# **SERVICE BULLETIN**

**Owner's Service Bulletin – OSB 29 Draft Issue 1**

**Applicability – Ikarus C42 all models**

**Inspection of main fuselage tube for cracking around cut-outs**

## Location and Examples

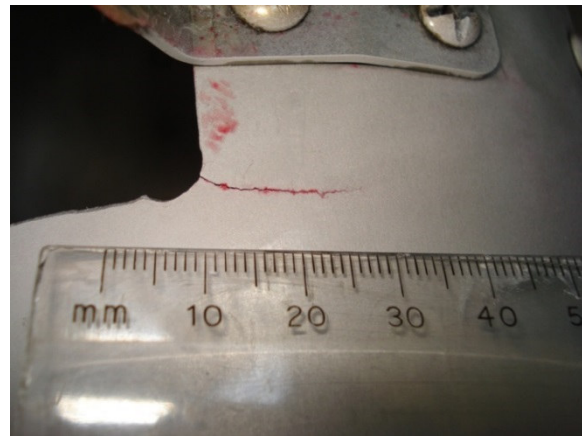
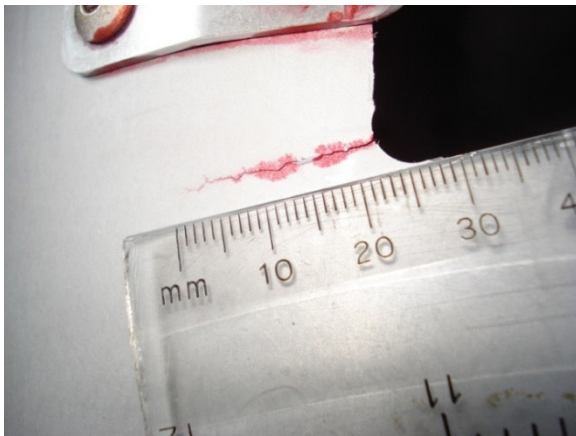
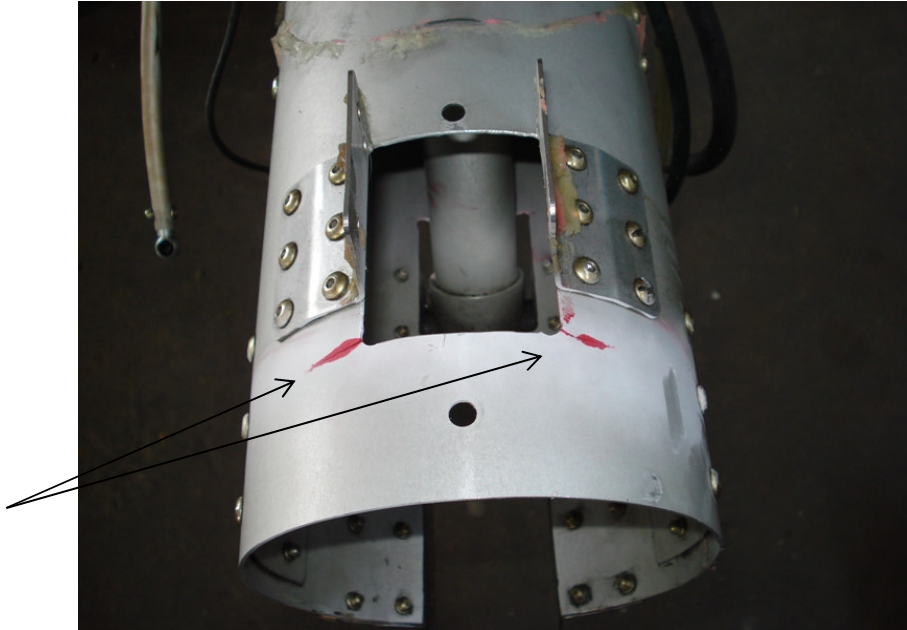
Nose-leg and A-strut cut-outs at front of main fuselage tube in vicinity of engine mount.

- Notes: 1. the stainless steel brackets securing the A-strut to the top side of the fuselage tube (the rearmost brackets shown above) were lengthened compared to those shown in the diagram above in around 2007, see the photo further below.
2. the holes for the A-strut attachment (the rearmost set of holes, one in the top of the main fuselage tube, one in the bottom) were eliminated entirely around 2015.

Example cracks on lower surface of main fuselage tube at corners around A-strut cut-out.

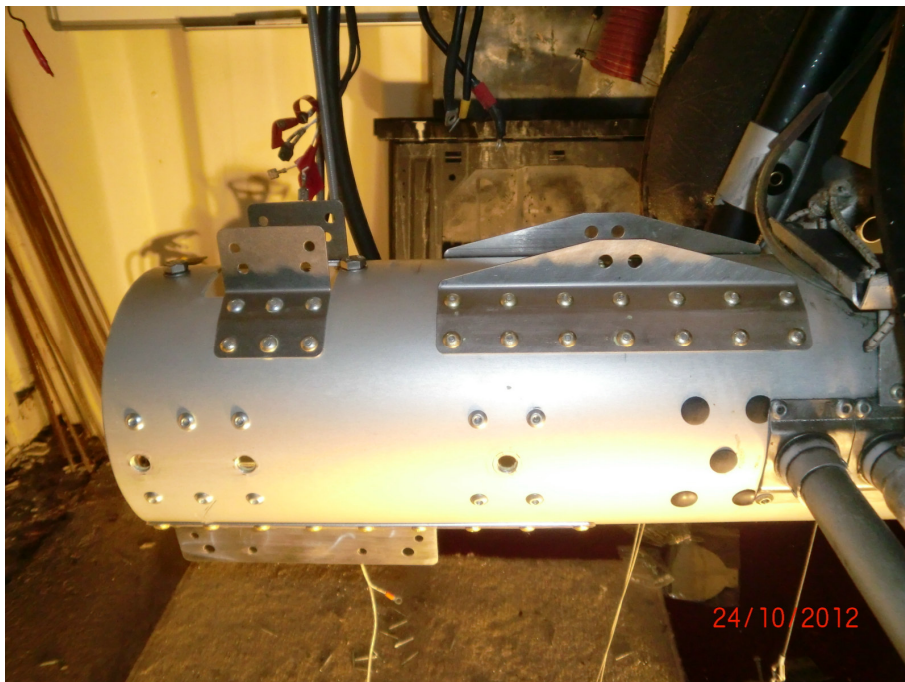
Example of significant crack allowed to propagate on 4500hr aircraft. This crack was hidden by the firewall sound-deadening foam. Ensure that it is removed for inspection.

Remove the area of sound-deadening foam on the cockpit side of the firewall which hinders inspection of the A-strut cut-out just forward of the rudder pedals on the top of the main fuselage tube. This is the area which concealed the significant crack shown in the example photographs above.
